**JOINT REGIONAL PLANNING PANEL  
(Sydney East Region)**

JRPP No	2014SYE140
DA Number	13/200/02
Local Government Area	City of Botany Bay
Proposed Development	Section 96(2) application to modify Development Consent No. 13/200 including to make various minor changes to the approved building design; convert 88 residential apartments to 124 serviced apartments which will reduce the total residential apartments from 899 to 811, and increase the total serviced apartments from 262 to 386; increase the retail areas on level 2 Quadrant 2; and slightly narrow in part the through site link; increase the GFA by 1,958m <sup>2</sup> as a result of changes to the unit configuration and uses; and amend the elevations as a consequence of the changes in unit size and uses.
Street Address	19-33 Kent Road, Mascot
Applicant/Owner	Karimbla Construction Services (NSW) Pty Ltd
Number of Submissions	One (1) objection
Regional Development Criteria (Schedule 4A of the Act)	Section 96(2) Application to modify a consent determined by the JRPP

**Assessment Report and Recommendation Cover Sheet**

**Figure 1** Approved Level 2

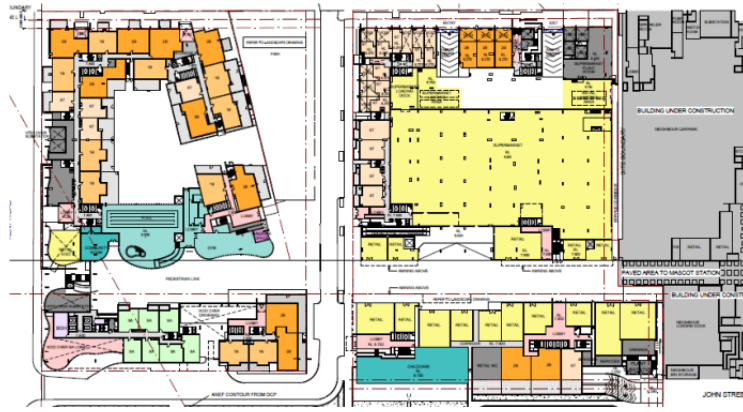
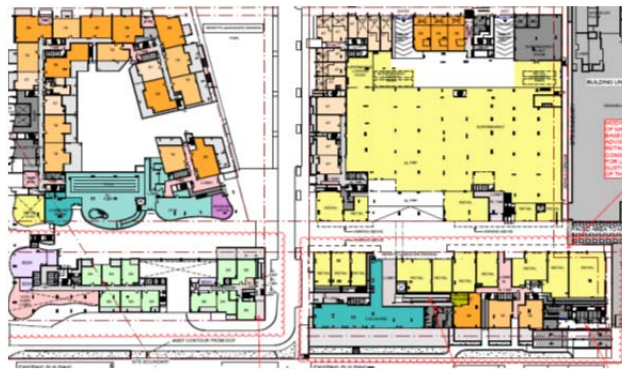
As advised by the applicant, this change is proposed in order to maintain viability of the shops, presumably to ensure a reasonable floor area results. The applicant's amended plan shows that in part, the through site link on level 2 is reduced by the increase in the retail space retail areas by three metres. This affects the southern retail spaces only. **Figure 1** indicates the extent of additional retail floor area/reduction in the link. The courtyards of new serviced apartments converted from residential units will also extend into the through link.

The changes also incorporate a reconfiguration of the retail spaces to allow better access into the residential lobby and child care centre entry. The resulting separation distance between the retail spaces will range from 12m to 27m.

The proposed changes to the retail spaces and Level 2 Quadrant 2 result in a minor **increase in total GFA** of 169m<sup>2</sup> from 2,461m<sup>2</sup> to 2,630m<sup>2</sup>, resulting in an increase in FSR from 3.72:1 to 3.73:1. This variation is supported in this instance, as there is minimal impact from the proposed additional floor area at Level 2 Quadrant 2.
